Art Haus

469-483 BALMAIN ROAD

Supplementary Submission

Revised Concept - Summary of Changes

Setbacks

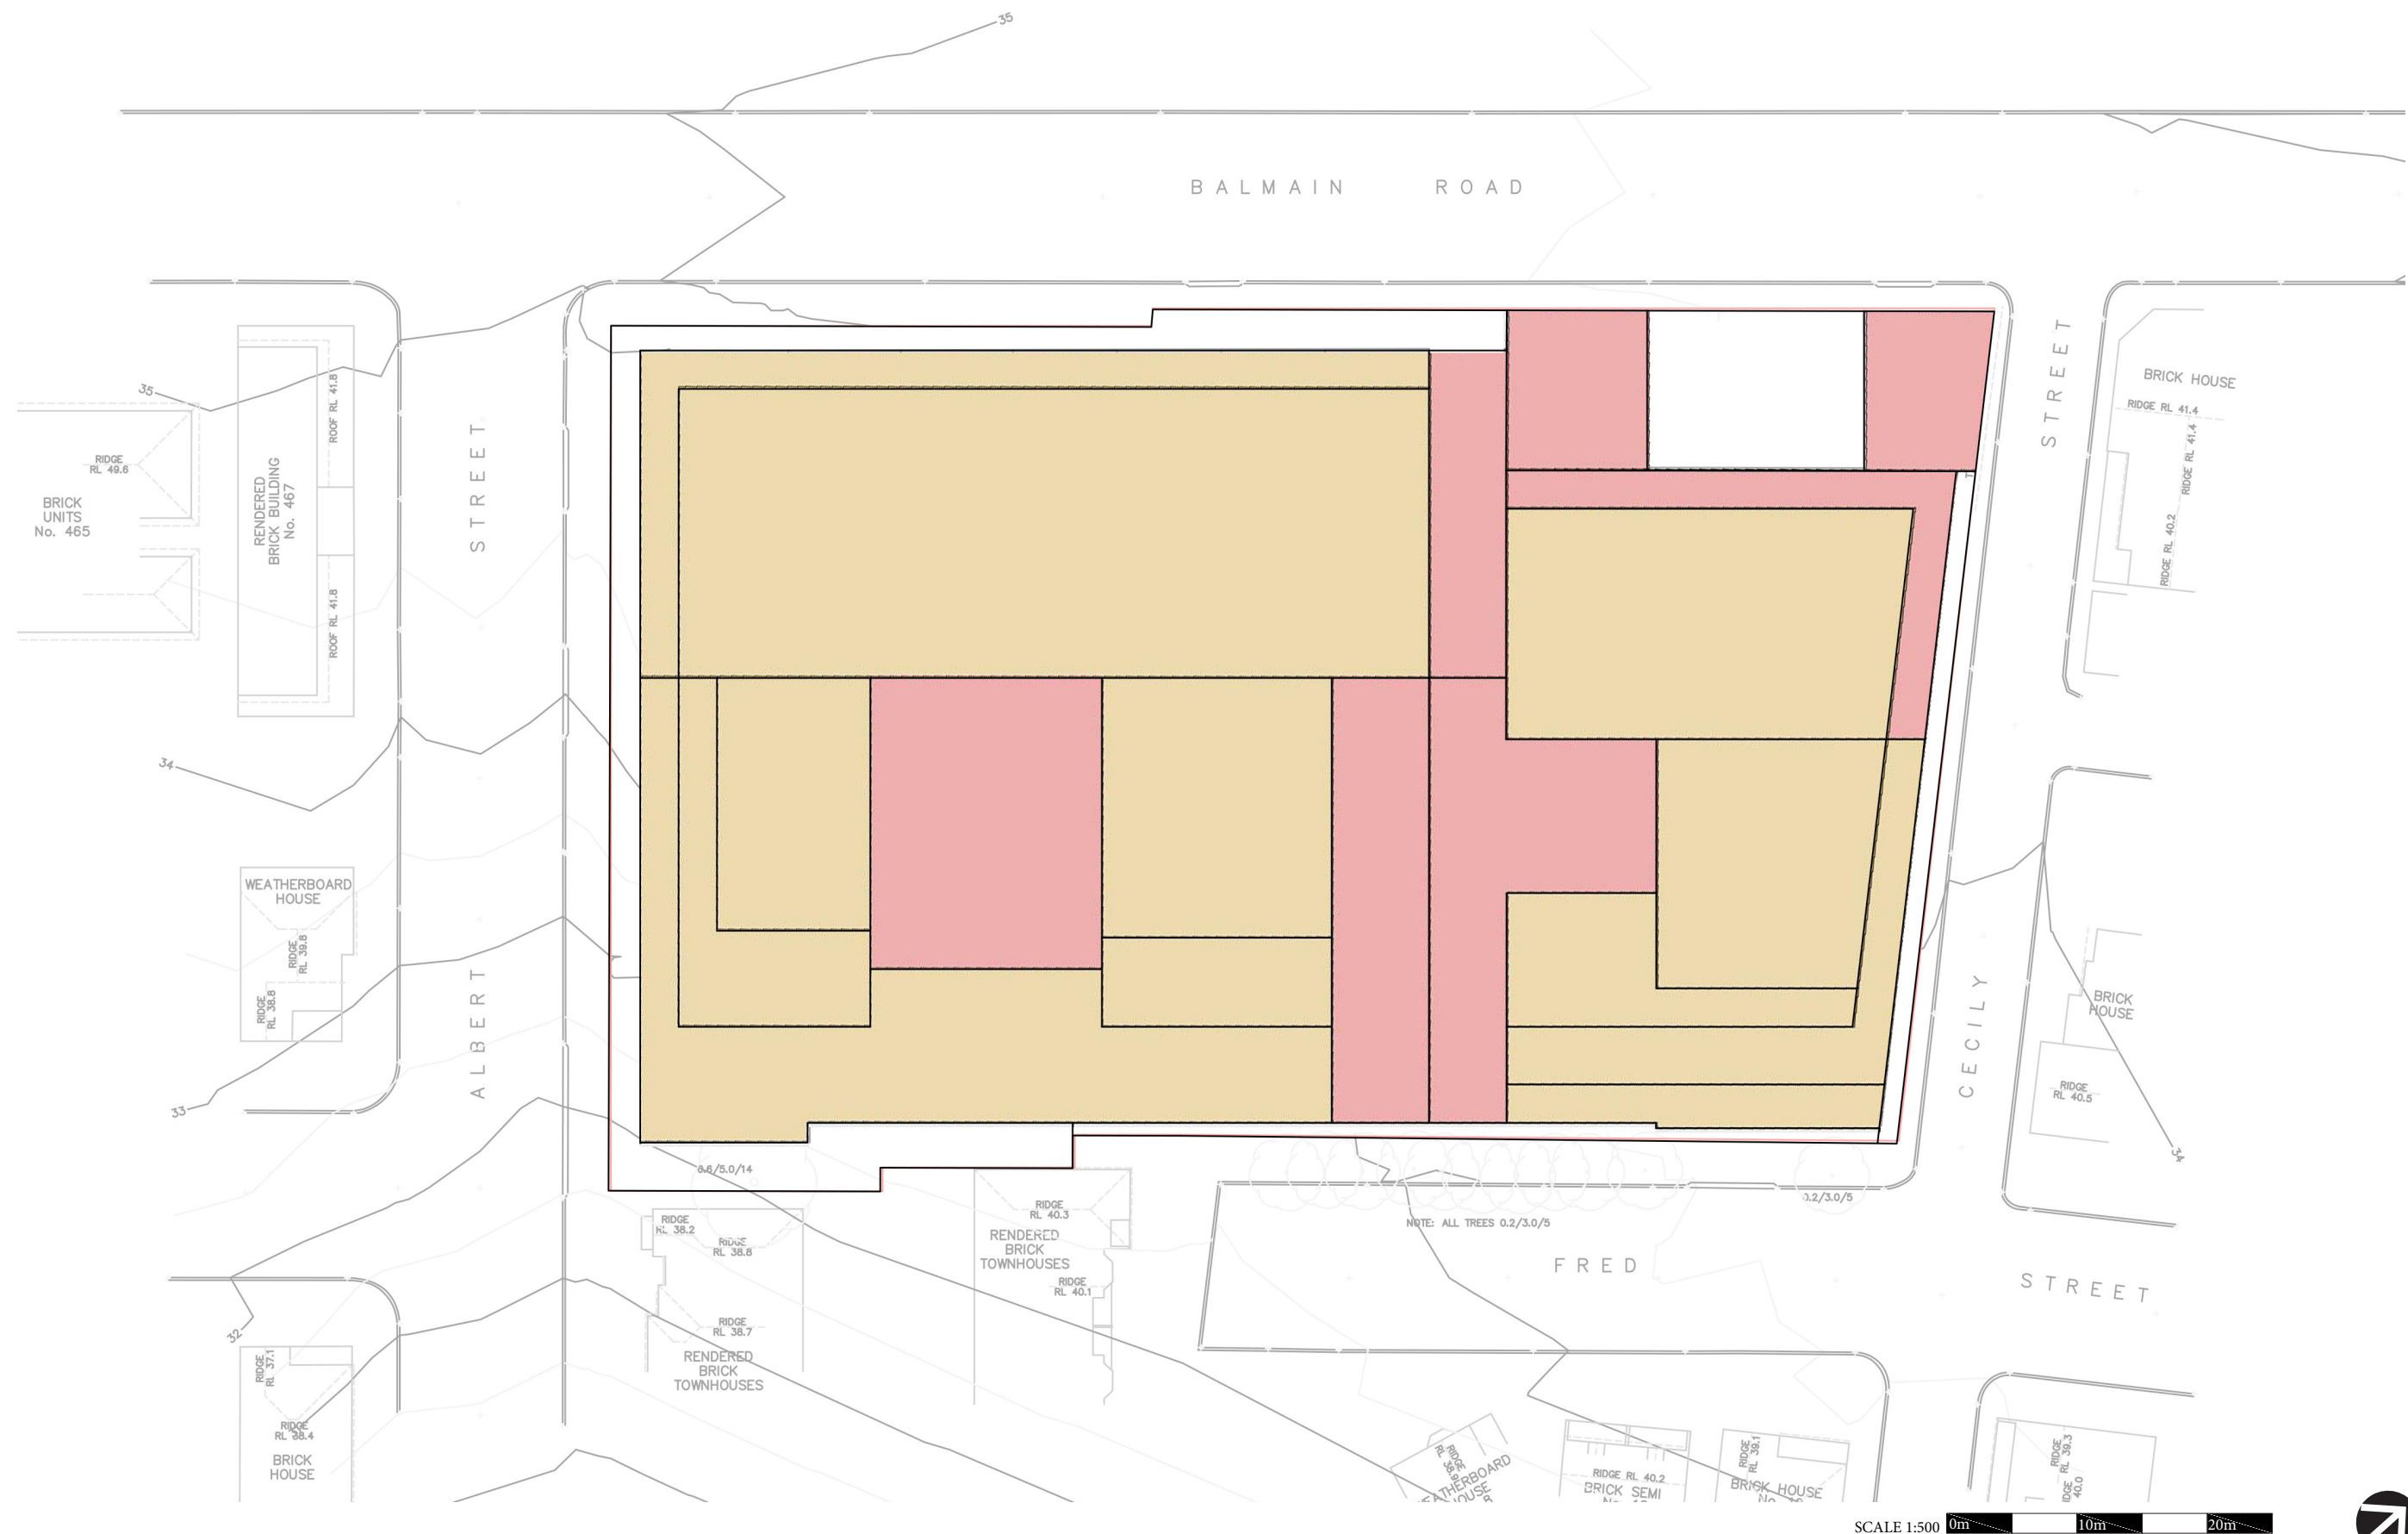
Council request	Design response
Council will consider additional controls for the site such as a minimum residential setback from the eastern boundary in light of the sites interface with other industrial uses.	There are no existing, adjoining land uses to the east that would result in a land use conflict. But, the revised Proposal does provide appropriate horizontal and vertical setbacks to avoid any future conflicts.
The residential component adjacent to the heritage character buildings should be setback further so that the six storey component is not directly adjacent to these buildings to ensure the heritage integrity of these buildings is retained.	It is noted the retained character buildings are not classified as 'heritage'. Notwithstanding, based on Council's advice the residential component has been setback an additional 3m from the retained character buildings.

Revised Ground Floor - Employment and Circulation

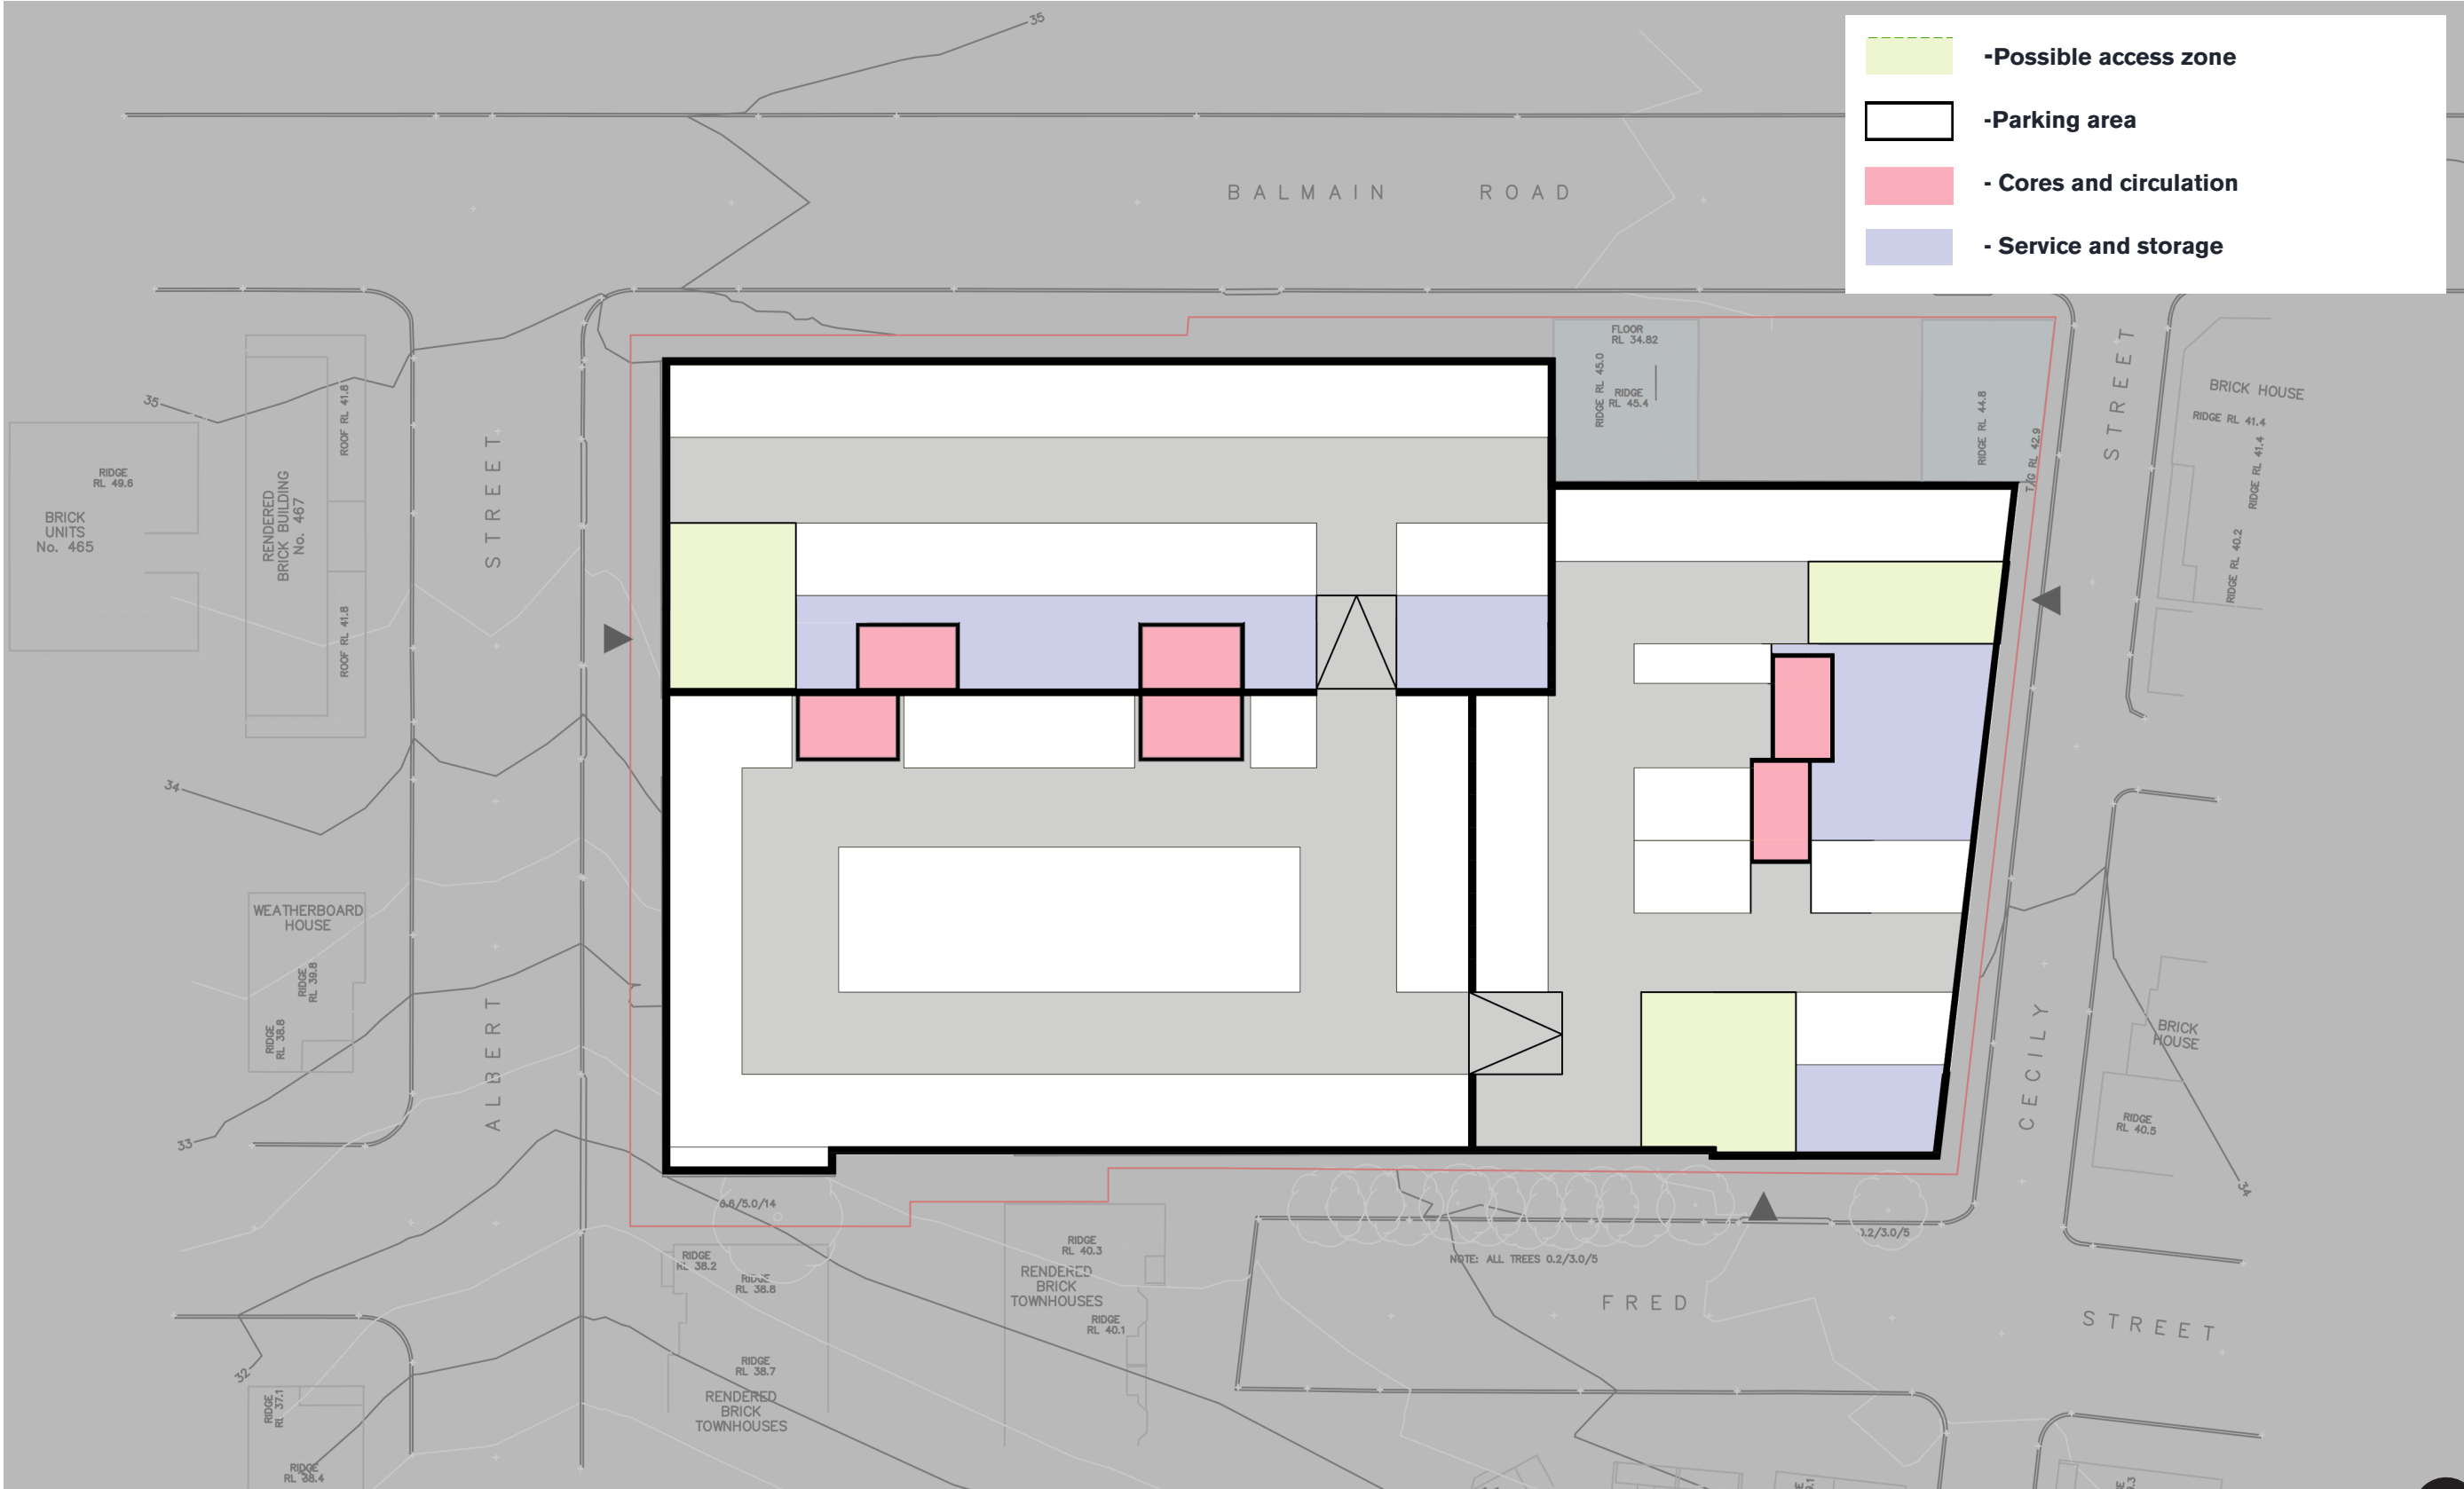
Council request	Design response
Council supports the retention of a minimum of 6,000m2 for employment uses.	The revised Proposal has 6,000m2 of employment floor space located across the entire ground floor and part of the first floor around the retained character buildings. With generous floor to ceiling heights set by the retained character buildings, the employment floor space is adaptable and flexible.

Revised Height - Illustrative Cross section

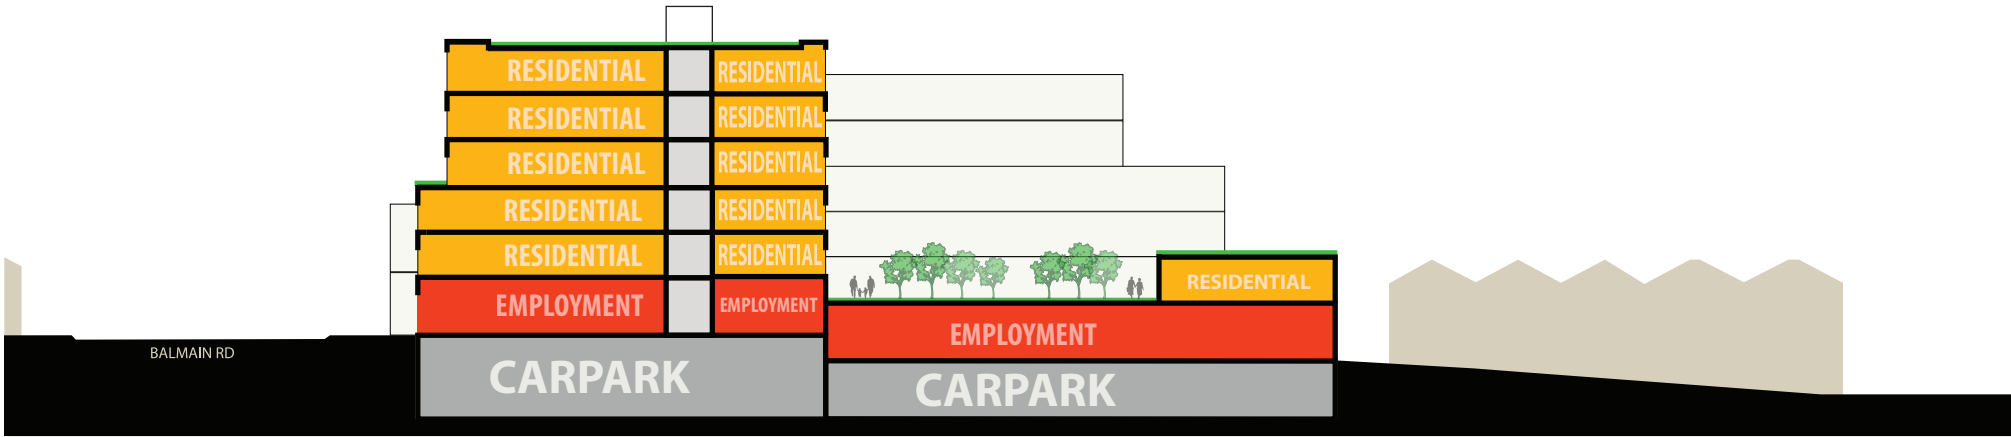
Council request	Design response
Council will consider a maximum 6 storey building height including both employment and residential uses.	The revised Proposal has a maximum 6 storey height located towards the Balmain Rd frontage. A context responsive building envelope then steps down in height towards the other street frontages including: 2 to 4 stories along Alberto St; 3 to 6 stories along Cecily Street; and, 2 stories along Fred St.
Maximum height controls will be specified for both the employment and residential components.	The revised Proposal vertically integrates employment and residential uses. As such, the proposed maximum height is 6 storeys.
Concept design are ADG compliant and minimise privacy and solar impacts on adjoining properties.	At this stage of the process the Proposal is ADG compliant. Consistent with the original Planning Proposal, the revised Planning Proposal provides adequate solar amenity to adjoining properties. Between 9am and 11am on 21 June, although there is some overshadowing on adjoining properties along Alberto St, it essentially falls onto blank walls, garages and fences. Similarly, properties along Fred St receive fall sunlight during the morning. Whilst there is increased overshadowing in the afternoon it is located with the road and existing built form, rather than private open spaces.

One and two storey residential should be considered nearest to Fred St and Alberto St properties.	It is noted the existing buildings largely present as 3 storey blank walls to the surrounds. Notwithstanding, the revised Proposal presents as two storey buildings to Fred St and Alberto St.
Responding to the above will determine appropriate floor space.	In responding to the above the proposed FSR is 2.54:1. Despite a reduction in building height and residential floor area from the original Proposal, the proposed FSR has increased due to the significant increase in employment floor space requested by Council.
